Access Compliance Report

Public Rights-of-Way

Intersection ID: 48024	Main Street: LADLEY_CT	Cross Street: OLD_PROVIDENCE_RD	Location: W
ADA ID: ECC283793148	Ramp Type: PerpDiag	Initial Pass/Fail: Fail	Overall Compliance: No
			Severity Score: 21.25

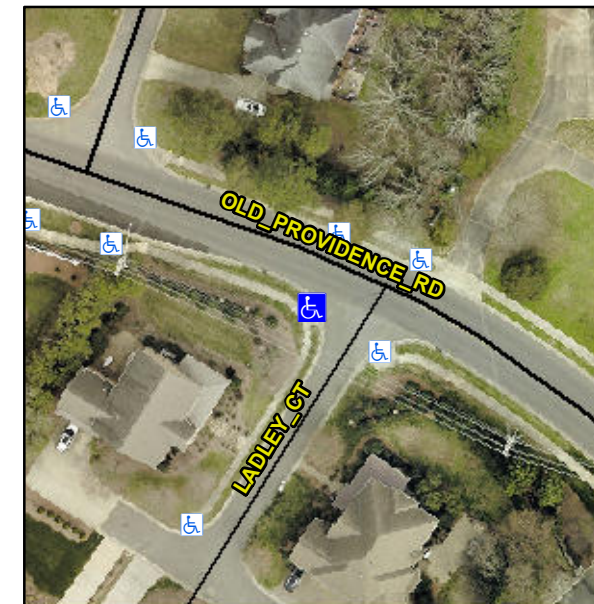
Not Found, R304.5.1, R304.2.2

Compliance	Description	Data	Compliance	Description	Data
N/A	Ramp Length (in)	54.0	No	Ramp Slope (%)	10.3
No	Ramp Width (in)	46.0	Yes	Ramp XSlope (%)	0.4
N/A	Flare Type LT	N/A	N/A	Flare Type RT	N/A
N/A	Flare Slope LT (%)	N/A	N/A	Flare Slope RT (%)	N/A
N/A	Flare Traversable LT?	N/A	N/A	Flare Traversable RT?	N/A
N/A	Landing Length (in)	N/A	N/A	DWS Provided?	N/A
N/A	Landing Width (in)	N/A	N/A	DWS Contrast?	N/A
N/A	Landing Slope (%)	N/A	N/A	DWS Length (in)	N/A
N/A	Landing X Slope (%)	N/A	N/A	DWS Full Width?	N/A
N/A	Landing Curb? (Y/N)	N/A	N/A	DWS Offset (in)	N/A
N/A	Shared Landing?	N/A			
N/A	Gutter Ponding?	N/A	N/A	Gutter Slope (%)	N/A
N/A	Gutter Lip Ht (in)	N/A	N/A	Gutter X Slope (%)	N/A
N/A	Painted X Walk1?	No	N/A	Painted X Walk2?	No
	X Walk 1 Direction	To SE		X Walk 2 Direction	To NE
N/A	X Walk 1 Width (in)	N/A	N/A	X Walk 2 Width (in)	N/A
	X Walk 1 Slope (%)	0.1		X Walk 2 Slope (%)	2.0
	X Walk 1 X Slope (%)	2.8		X Walk 2 X Slope (%)	0.2

Remove & Replace Curb Ramp With Two New Directional Ramps or Equivalent.
